KNOXVILLE HISTORIC ZONING COMMISSION STAFF REPORT - CERTIFICATE OF APPROPRIATENESS APPLICATION

FILE NO.: 2-F-19-HZ

APPLICANT: Evian Partners Robert and John Holmes (owners)

LEVEL OF WORK: Level II. Demolition and reconstruction of addition

East Side:

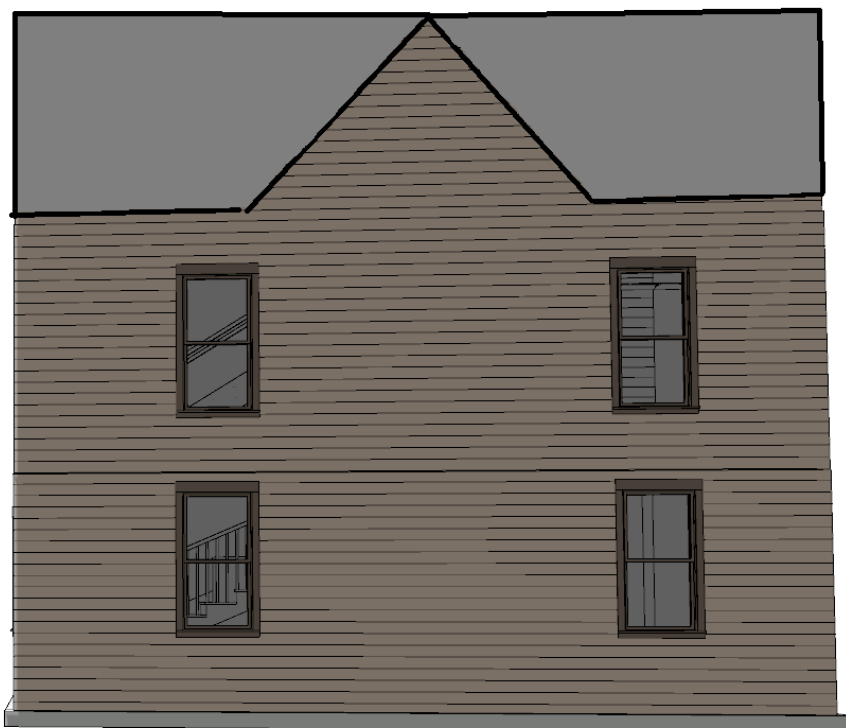
6) The option of continuing the stuccoed foundation along the entire east (16th Street) elevation up to the addition is more appropriate than continuing the siding down to the basement level.

7) Relocating the basement door to the left by 18 inches does not have significant impact; however, the window above it should be located as closely to the middle of this wall section as possible in order to replicate the original placement.

The door on the East side will need to move 18" to the left to accommodate the firewall which must be built inside the house to meet building code requirements.

The yellow line is the dirt line. Exposure of the porch foundation above grade will range from 1' 6" at the front of the porch to 4' 2" at it's connection to the main house. It continues sloping downwards from 4' 2" to 6' 6" to the left side of the bay and then downwards further to 7' 2" at the addition.

Rear Addition roof plan:

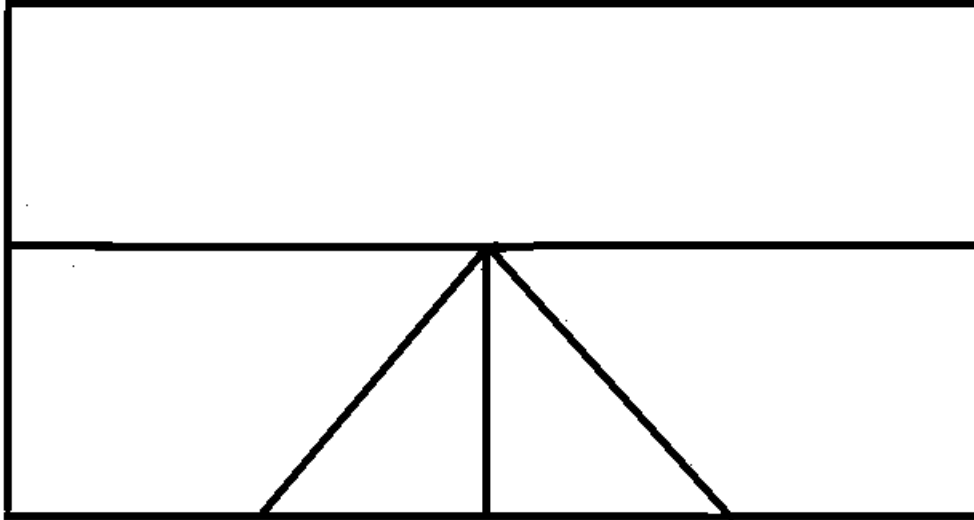
No changes are proposed to the existing roof plan shown below.

SURVEY FOR **EVIAN PARTNERS**
DIST. **4** WARD **10** CITY OF **KNOXVILLE** COUNTY **KNOX**
ADDRESS **1601 FOREST AVE.**
LOT NO. **PART OF 55** BLOCK _____ UNIT _____
S/D **RAMSEY'S ADDITION**
INSTR. **201403080054916** SCALE **1"= 20'** DATE **2-12** 2018
JOB NO. **1802002** ORDERED BY: **INDEP.**

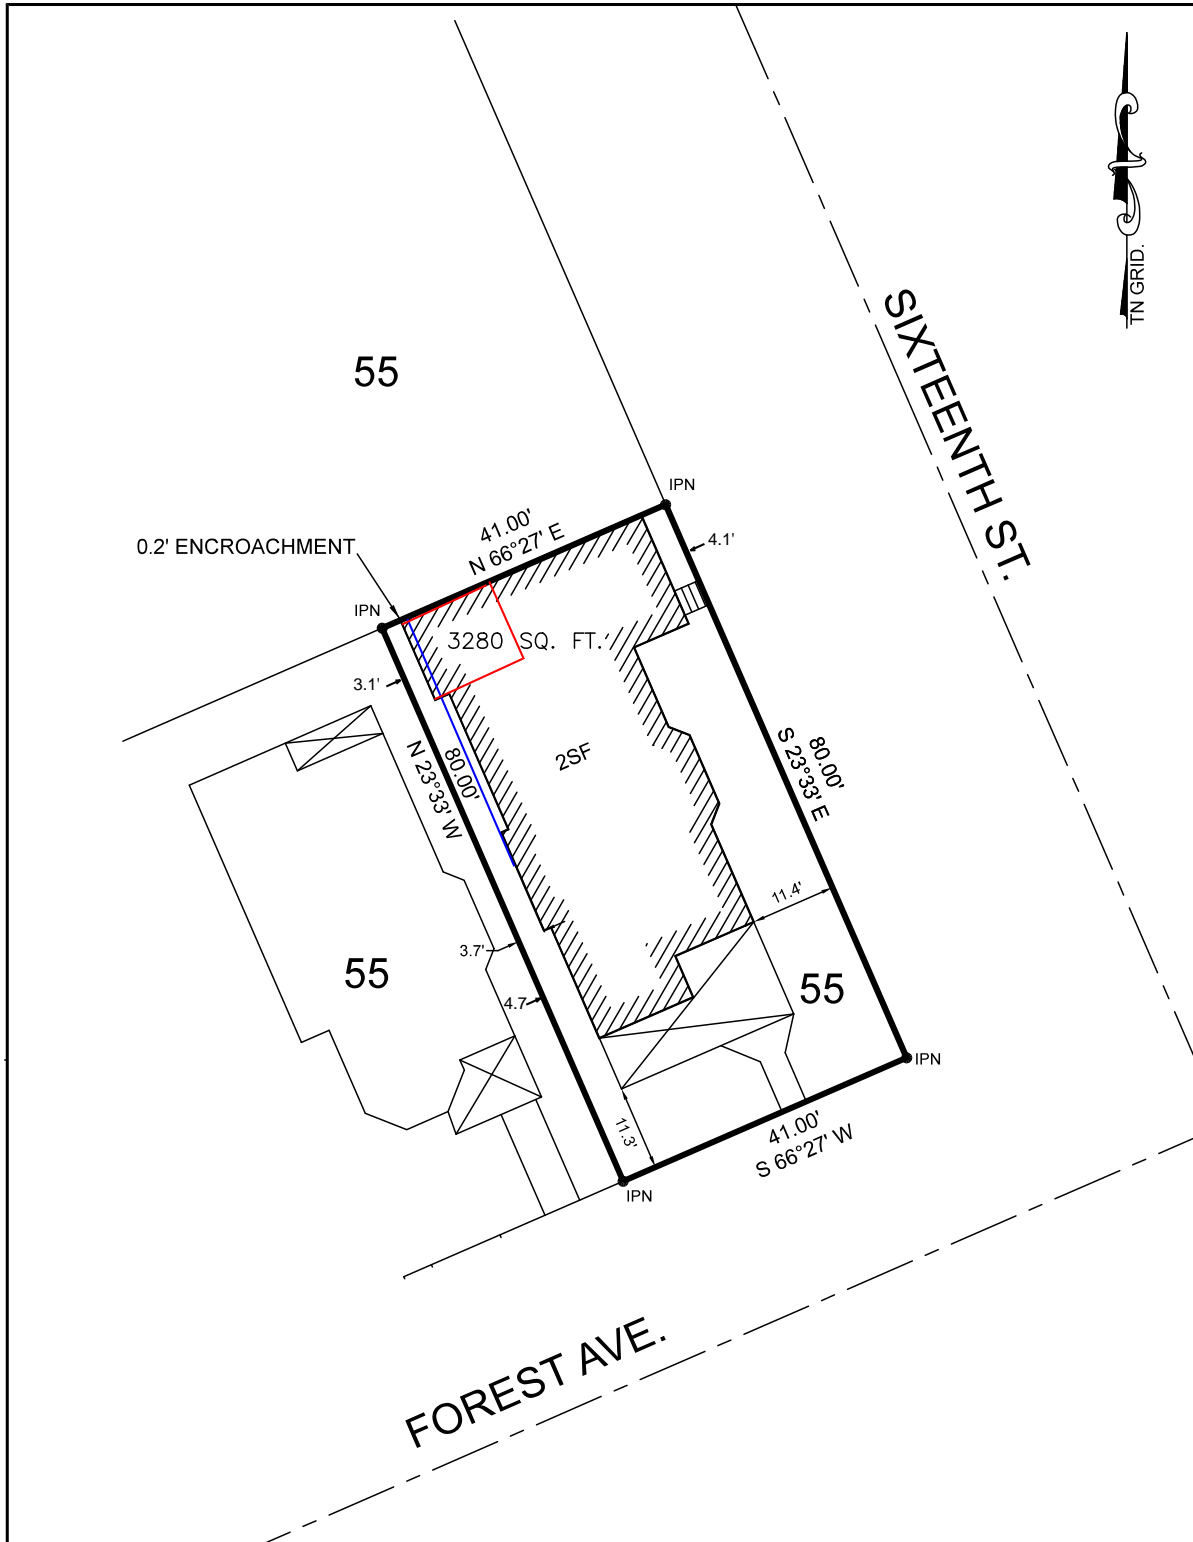
- 1) The house is a contributing structure with the Fort Sanders NC-1 and the National Register Historic District.
- 2) The demolition of the east and west walls, foundation, and the west portion of the addition (as outlined in red on the site plan) was permitted after-the-fact by City Development Services.

Rear Addition: The Rear addition of the house as indicated on the attached survey is in poor structural shape and will need to be largely restored, it is intended to be restored exactly as it was built. A section to the back left as indicated in red on the survey has been removed as it was structurally unsound and is pending reconstruction. The building department has determined that it may be rebuilt, but the bump out must be in line with the existing house bump out, pending COA approval. This is indicated by the blue line on the survey (This is an approximately 6" reduction in the East side dimension). There is a 2" encroachment along the rear that will have to be fixed at the same time.

4. The rear addition is recommended to be demolished since it is not historically appropriate, but may be rehabilitated as proposed if permitted by City Building Inspections with approval of the door, entrance overhang, and window specifications to be approved by staff. The shutters for the faux windows shall be louvered and placed within window framing and have hinged hardware, although they are not required to be operable.
